UNITED STATES PATENT AND TRADEMARK OFFICE

APPLICATION NO.	FILING DATE	FIRST NAMED INVENTOR	ATTORNEY DOCKET NO.	CONFIRMATION NO.
10/684,765	10/14/2003	Desmond J. Latouche	2224-00300	3350
23505	7590	10/21/2004	EXAMINER	
CONLEY ROSE, P.C. P. O. BOX 3267 HOUSTON, TX 77253-3267			NGUYEN, TRINH T	
			ART UNIT	PAPER NUMBER
			3644

Office Action Summary

DETAILED ACTION

line guide
having aperture

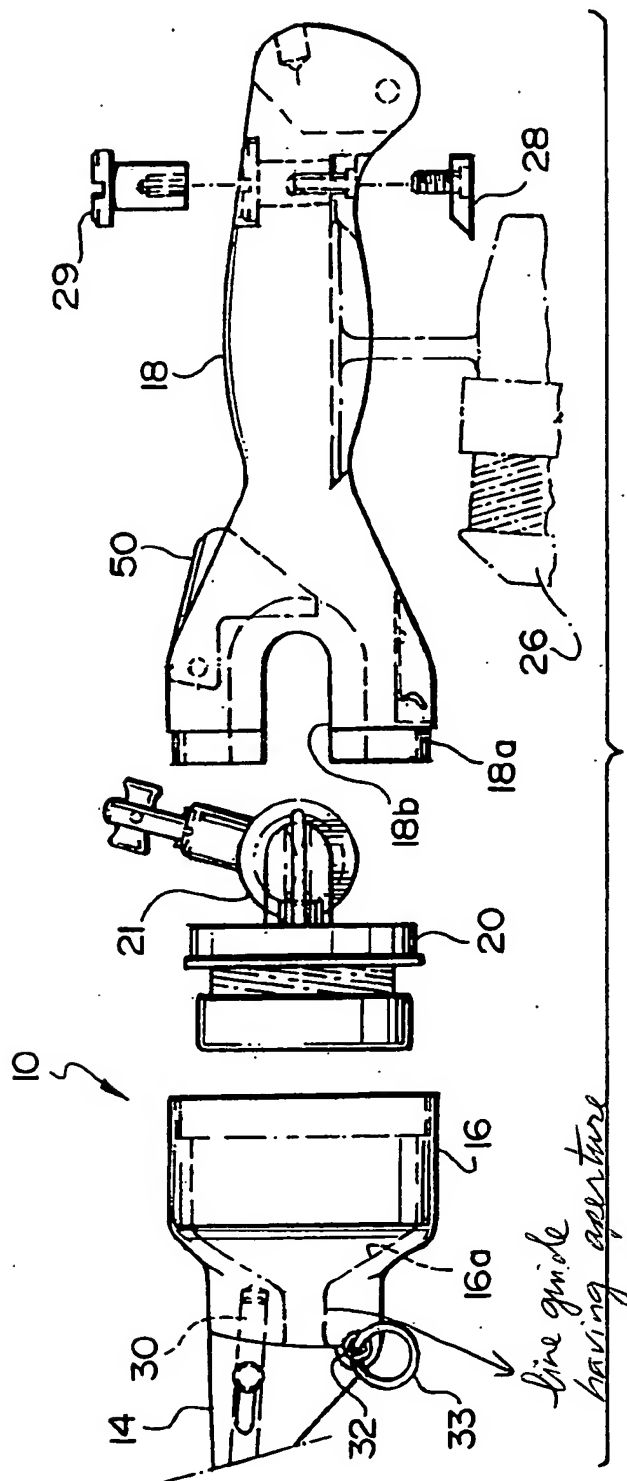
For claim 19, LaTouche further discloses elongated hollow body is provided with a line guide (see attached Figure 2 at the end of this Office Action) having a first aperture for guiding the fishing line. However, LaTouche does not disclose that the fishing line is guided inside the rod. Edwards et al. teach a similar device as that of LaTouche in which Edwards et al.'s device having a line guide (see attached Figure 2 at the end of this Office Action) having a first aperture for guiding the fishing line inside the rod. It would have been obvious to one of ordinary skill in the art at the time the invention was made to have modified the fishing rod of LaTouche so as to include a line guide for guiding the fishing line inside the rod, in a similar manner as taught in Edwards et al., since to do so would eliminate the fishing line from entanglement.

Fig. 2

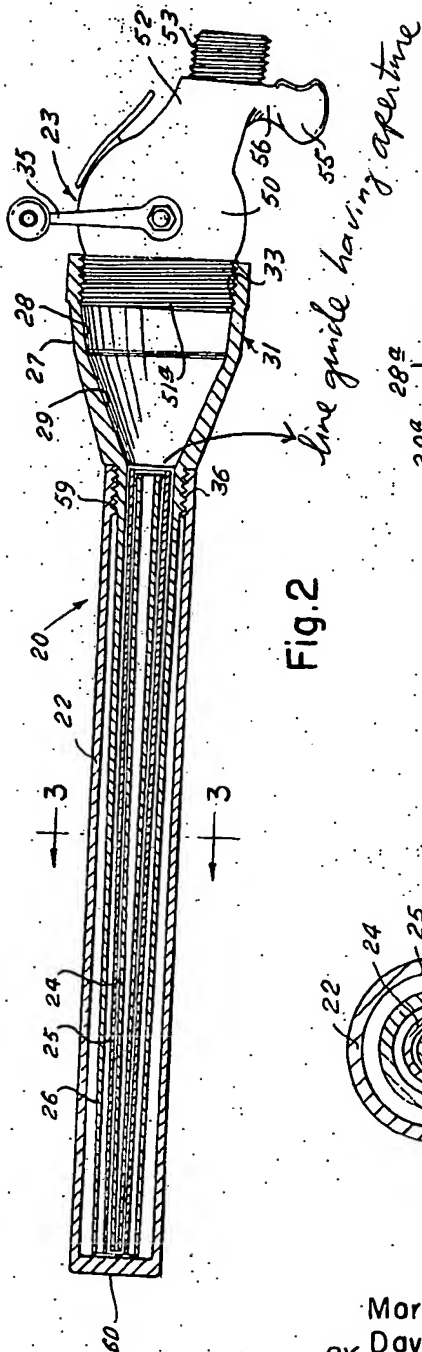
For claim 5, LaTouche discloses most of the claimed invention except for a hollow rod along its length. Edwards et al. teach a similar device as that of LaTouche in which Edwards et al.'s device having a hollow rod (see Figure 2). It would have been obvious to one of ordinary skill in the art at the time the invention was made to have modified the fishing rod of LaTouche so as to include a hollow rod, in a similar manner as taught in Edwards et al., since to do so would reduce the overall weight of the fishing device.
